GOVERNMENT OF MADRAS.

PUBLIC WORKS DEPARTMENT.

Residence for the Collector at Anantapur

Revised estimate for —, sanctioned.

No 1

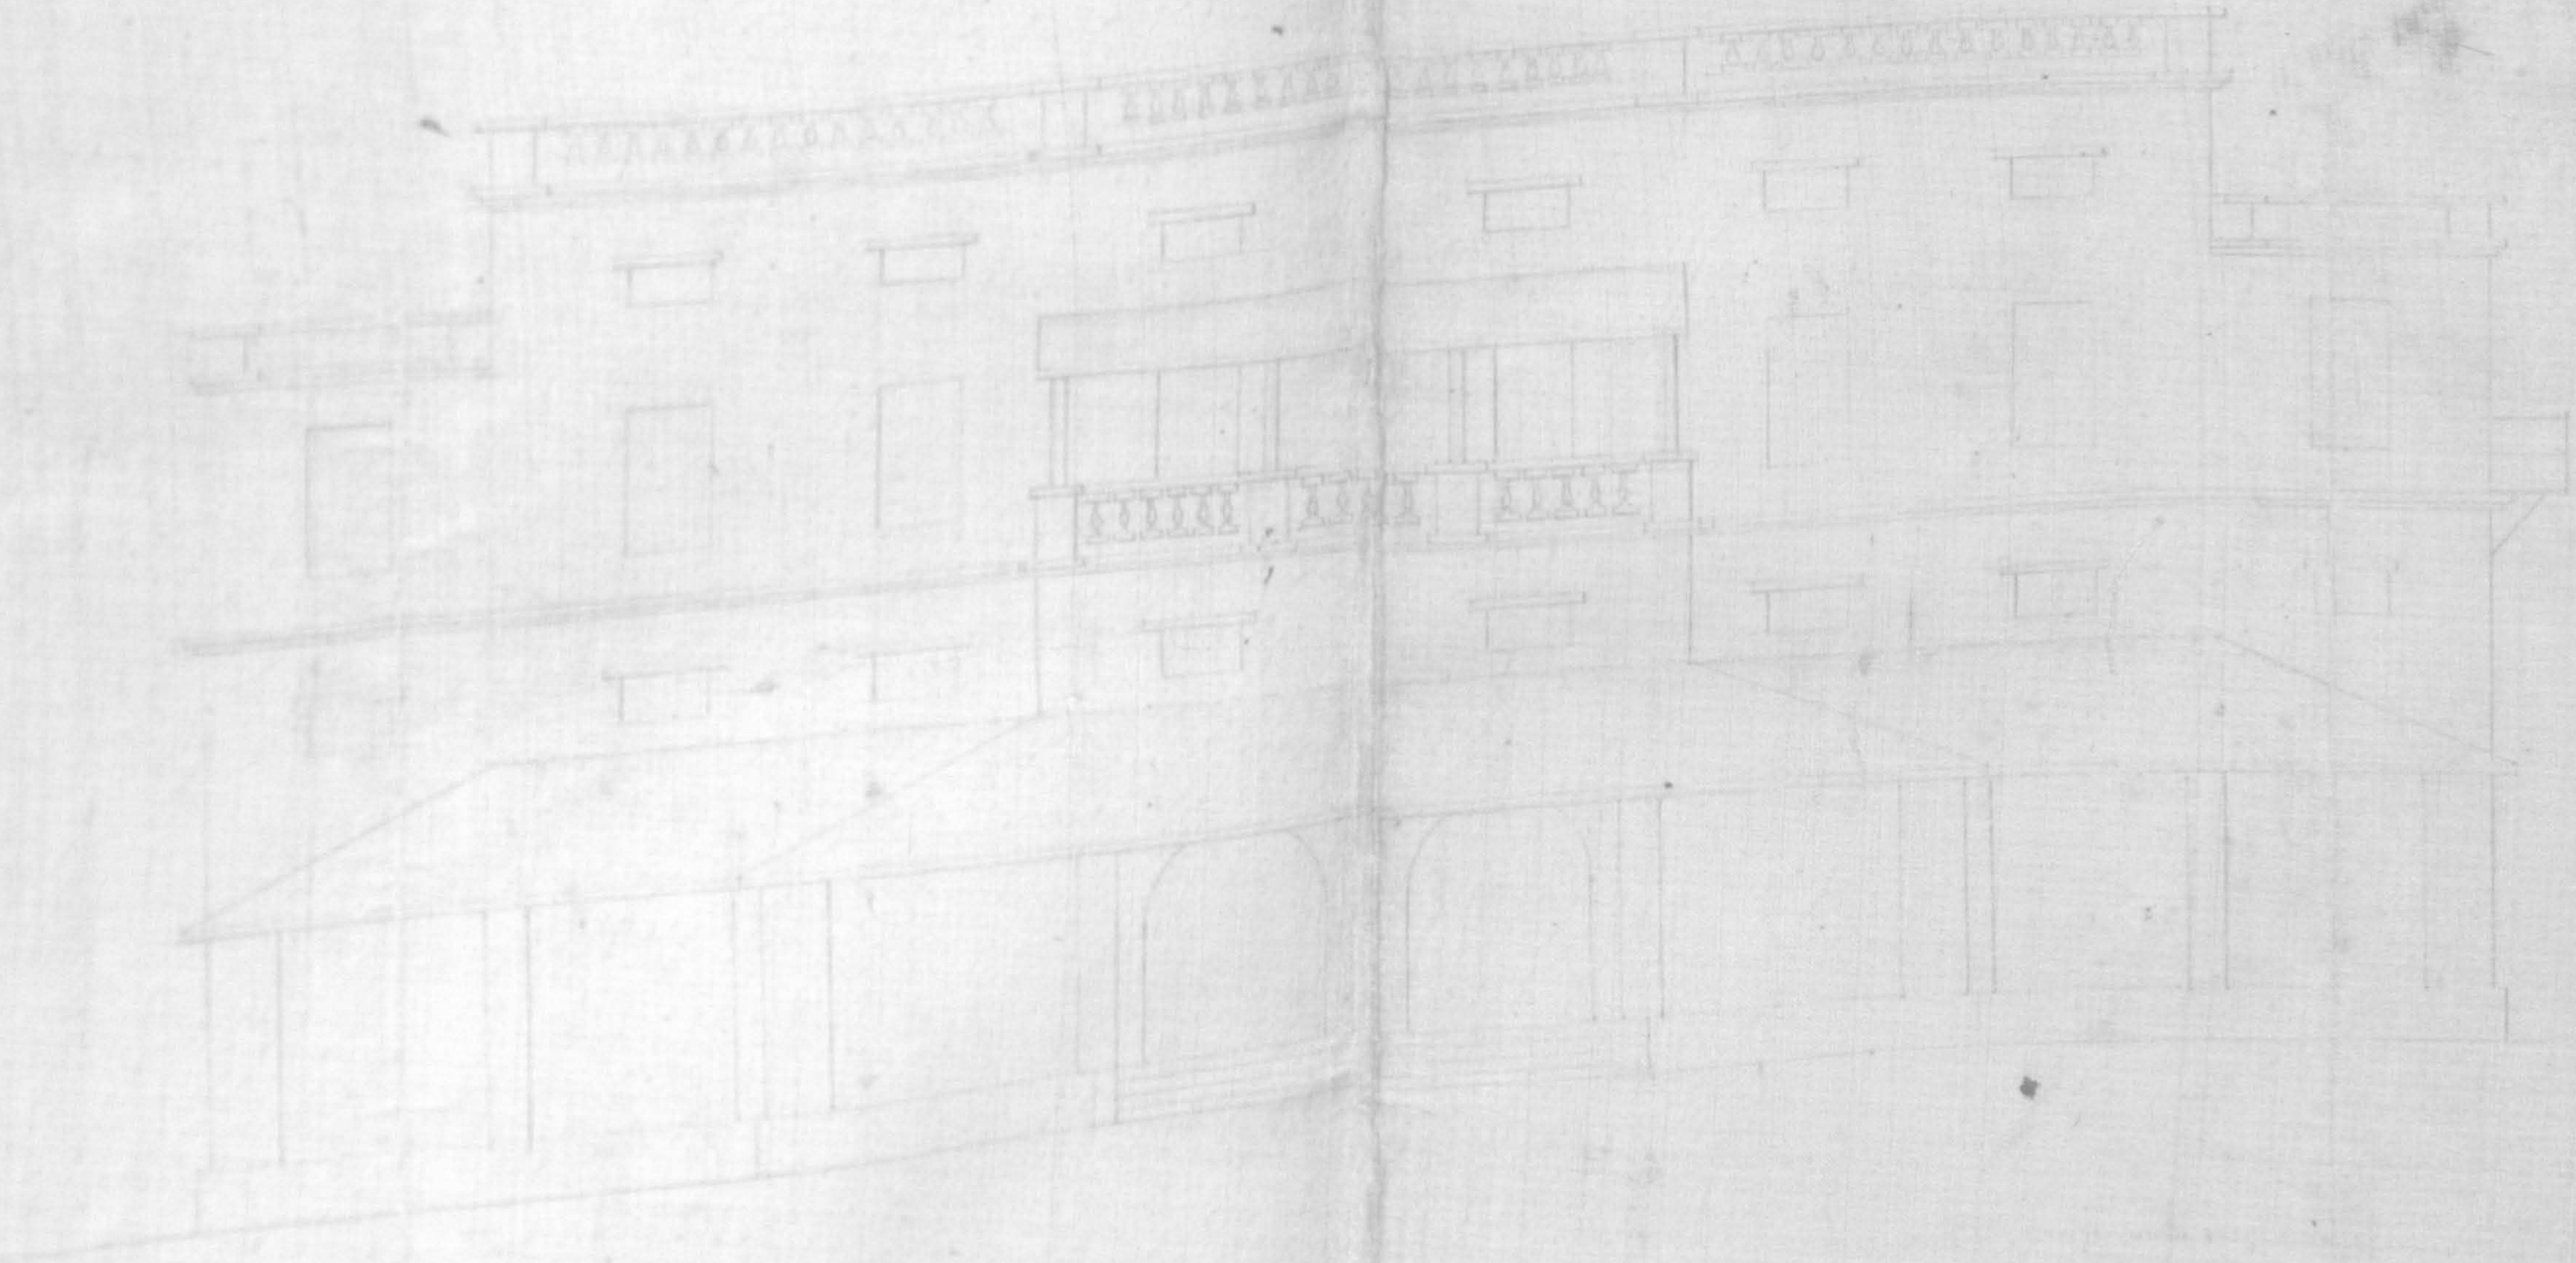
From this Office Memo No 3237C d/24th Sept: 1887 it is clear that all that was required to be done was to make the features (1) of the design accord with the elevation as shown on the left half of drawing No 2, (apparently the alternative design and which has not been sanctioned) to construct a cross wall (2) in the staircase room so as to divide it in two, and to construct a (3) landing outside to enable water to be taken up to the bath room &c, these suggestions have apparently been attended to.

NOTE IN THIS DRAWING, THE ROOMS W ARE THE SAME HEIGHT AS THE MAIN ROOMS, AND BATH ROOMS ARE ATTACHED TO EACH. THERE WOULD BE A LANDING TO CONNECT THE BATH ROOMS WITH THE LANDING AT THE BACK OF THE HOUSE. THIS ARRANGEMENT ADDS CONSIDERABLY TO THE ACCOMODATION AT A COMPARATIVELY SMALL COST.
